Access Compliance Report

Public Rights-of-Way

Intersection ID: 19146	Main Street: TYVOLA_RD	Cross Street: WEDGEWOOD_DR	Location: NW
ADA ID: 5A642621D820	Ramp Type: PerpDiag	Initial Pass/Fail: Fail	Overall Compliance: No
		Severity Score: 12.5

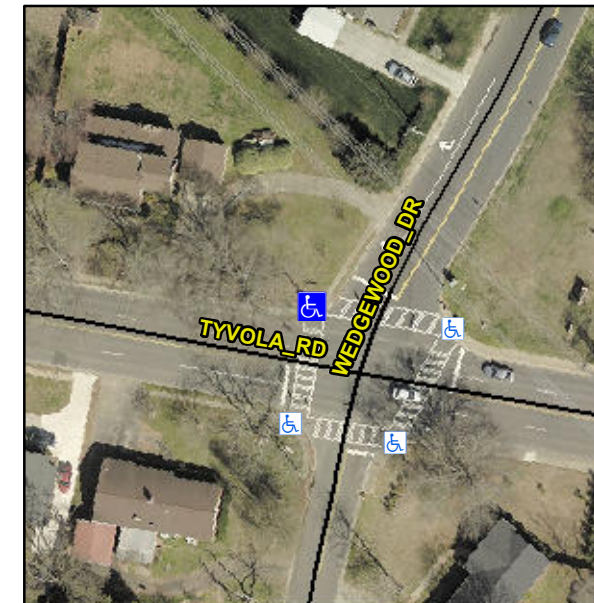
Not Found, R304.2.2

Compliance	Description	Data	Compliance	Description	Data
N/A	Ramp Length (in)	34.5	No	Ramp Slope (%)	10.5
Yes	Ramp Width (in)	96.0	Yes	Ramp XSlope (%)	0.7
N/A	Flare Type LT	N/A	N/A	Flare Type RT	N/A
N/A	Flare Slope LT (%)	N/A	N/A	Flare Slope RT (%)	N/A
N/A	Flare Traversable LT?	N/A	N/A	Flare Traversable RT?	N/A
N/A	Landing Length (in)	N/A	N/A	DWS Provided?	N/A
N/A	Landing Width (in)	N/A	N/A	DWS Contrast?	N/A
N/A	Landing Slope (%)	N/A	N/A	DWS Length (in)	N/A
N/A	Landing X Slope (%)	N/A	N/A	DWS Full Width?	N/A
N/A	Landing Curb? (Y/N)	N/A	N/A	DWS Offset (in)	N/A
N/A	Shared Landing?	N/A			
N/A	Gutter Ponding?	N/A	N/A	Gutter Slope (%)	N/A
N/A	Gutter Lip Ht (in)	N/A	N/A	Gutter X Slope (%)	N/A
N/A	Painted X Walk1?	Yes	N/A	Painted X Walk2?	Yes
	X Walk 1 Direction	To SW		X Walk 2 Direction	To SE
N/A	X Walk 1 Width (in)	107.0	N/A	X Walk 2 Width (in)	108.0
	X Walk 1 Slope (%)	6.2		X Walk 2 Slope (%)	5.6
	X Walk 1 X Slope (%)	2.8		X Walk 2 X Slope (%)	3.1

N/A	Ramp inside XWalk1?	No	N/A	Ramp inside XWalk2?	Yes
	Road Slope (%)	1.0	N/A	Clear Space?	N/A
	Road X Slope (%)	5.2	N/A	Clear Space to XWalk (in)	N/A
N/A	Any Obstructions?	N/A	N/A	Storm Grate/Utility Hazard?	N/A
	Obstruction Type			Storm Grate/Utility Type	
		N/A			N/A
			Yes	Surface Condition? (G/P)	Good

Remove & Replace Curb Ramp With Two New Directional Ramps or Equivalent. Restripe Crosswalk.
